AMENDMENTS TO THE DRAWINGS

### REMARKS

Title: Redistribution Layer Shielding of a Circuit Element

App. No.: 10/814,816

FIG. 5B

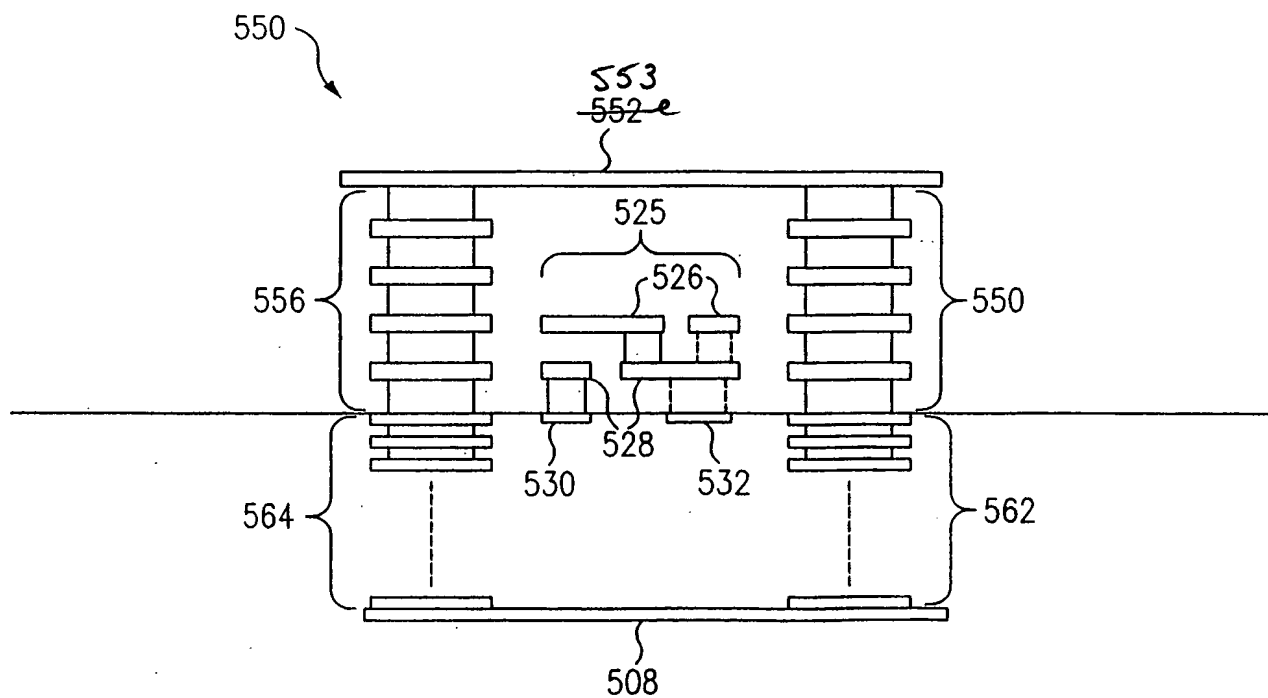
Figure 5B is amended to change the reference numeral of top plate 552 to top plate 553.

The specification is amended to be consistent with the drawings. The specification is amended to change the reference numeral of top plate 552 of FIG. 5B to top plate 553.

FIG. 9A

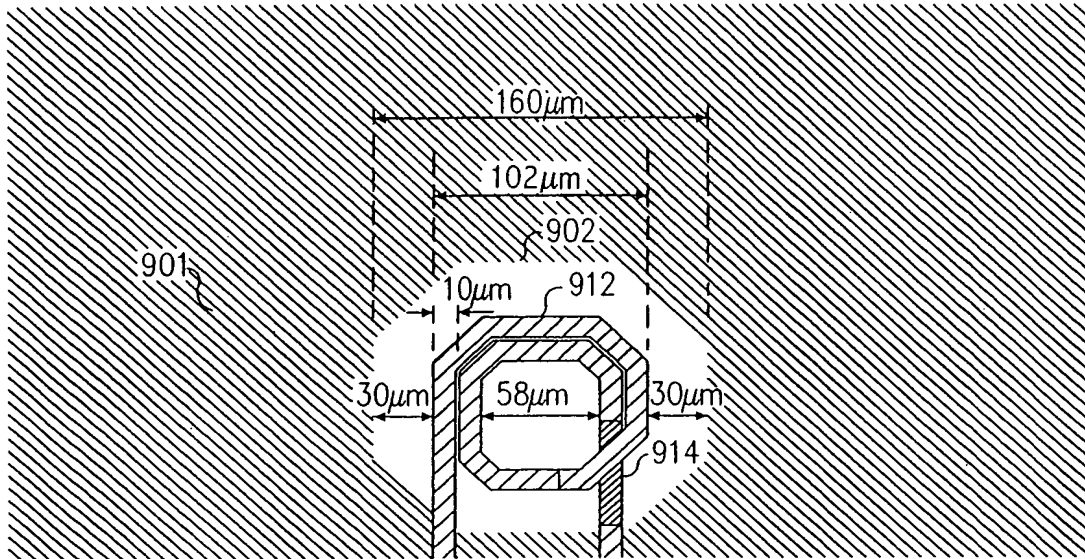
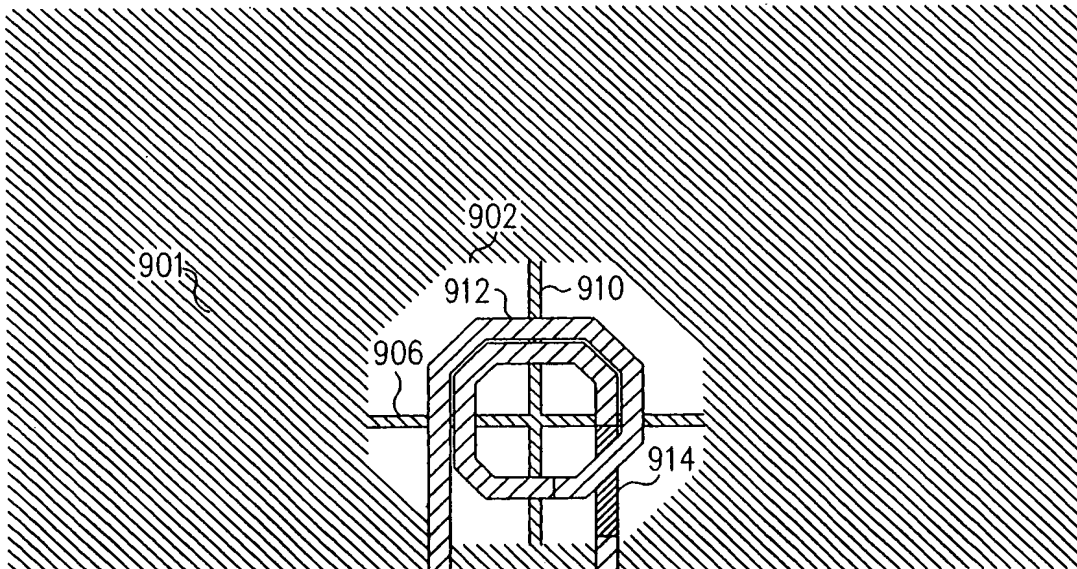
The drawings are objected to as failing to comply with 37 C.F.R. 1.84(p)(5) because they include the following reference characters not mentioned in the description: 1000, 1002, 1004, 1006, 1008, 1010, 1016, and 1066. Figures 9A, 9B, 9C and 10 are amended consistent with the specification.
